**PLANNED UNIT DEVELOPMENT
& SUBDIVISION STAFF REPORT****Date: February 7, 2008****SUBDIVISION NAME**

Gates at the Palms Subdivision

Planned Unit Development Approval to allow seven apartment buildings (183 units) and a clubhouse on a single building site and Subdivision approval to create one legal lot from two metes and bounds parcels.

DETAIL SITE PLAN

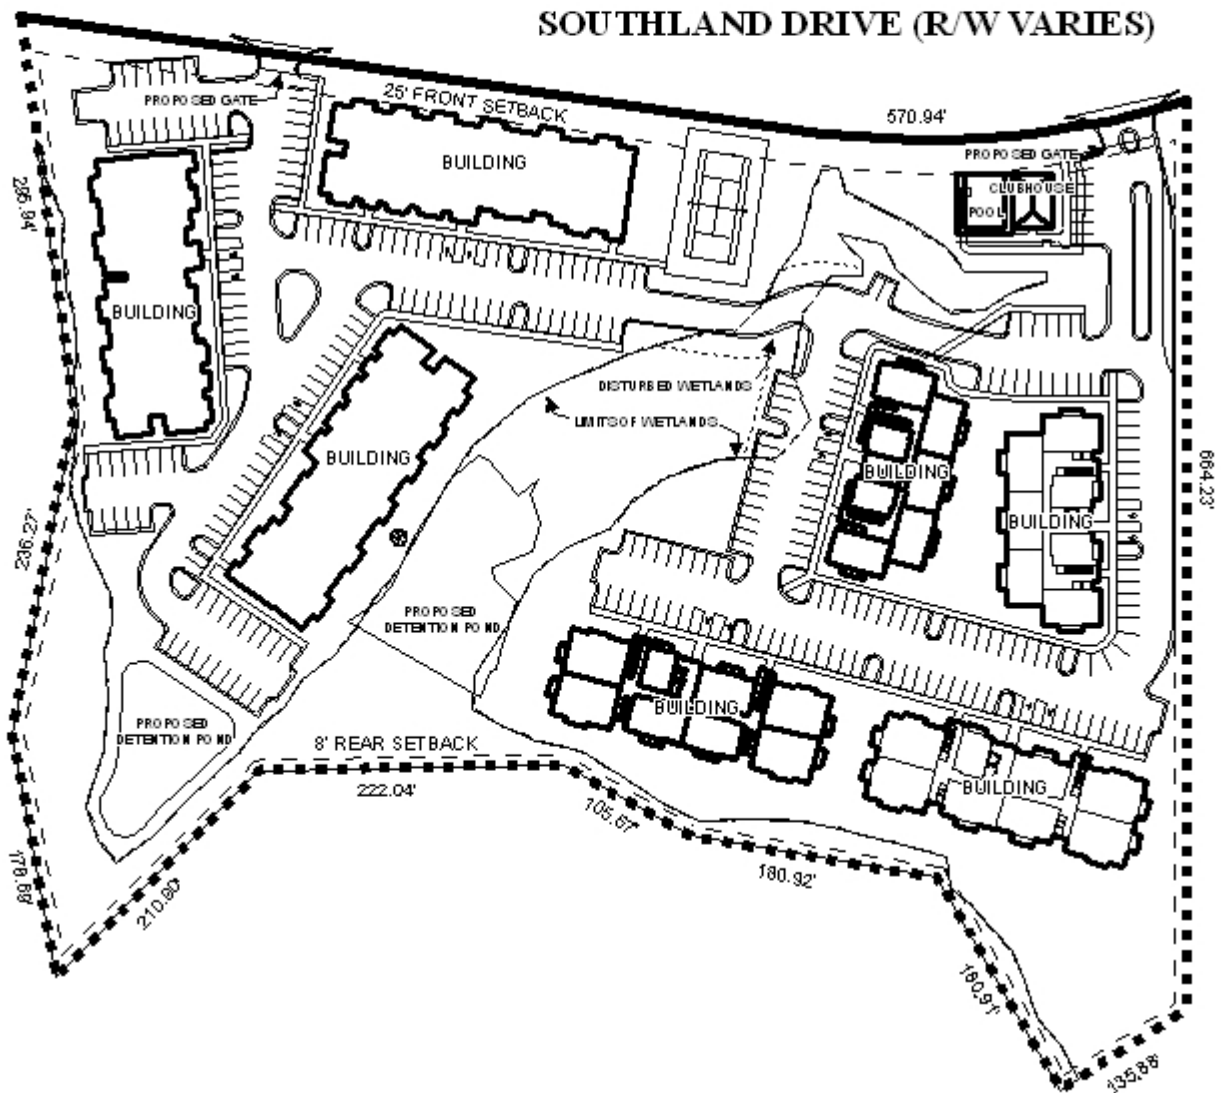
Clarify floodway, AE flood plain and X-shaded and unshaded flood hazard areas on map. Provide drainage easement for public water being conveyed onto the property; size and location to meet approval of City Engineering before plat is signed. No detention can be accomplished within the drainage easement. Developer's engineer must certify that the existing drainage system and outfalls can accommodate the proposed increase in coverage. In addition, detention for a 100-year storm with a 10 year discharge and/or outfall improvement may be required for any new development not already under construction. Any areas that discharge onto adjacent properties and not into a COM maintained system will require a release agreement. In addition, all stormwater detention should be accomplished above the AE Flood zone. Must comply with all stormwater and flood control ordinances. Any work performed in the right of way will require a right of way permit).

Driveway number, size, location, and design to be approved by Traffic Engineering and conform to AASHTO standards. Traffic impact study was received and reviewed. Developer will be responsible for intersection improvements at Knollwood and Southland Drive. For intersection safety, the developer must also restripe a dedicated left turn for southbound traffic as well as the recommended northbound left turn lane. Details plans of the intersection improvements must be approved by Traffic Engineering and Engineering.

The site plan depicts two storm water detention basins. A note should be placed on the site plan, if approved, stating that maintenance of the detention basin common area, and any other common areas, are the responsibility of the development's property owners.

1. *developer will be responsible for intersection improvements at Knollwood and Southland Drive;*
2. *the developer must also restripe a dedicated left turn for southbound traffic as well as the recommended northbound left turn lane; and*
3. *detailed plans for improvements must be approved by Urban Development, Engineering and Traffic Engineering.*
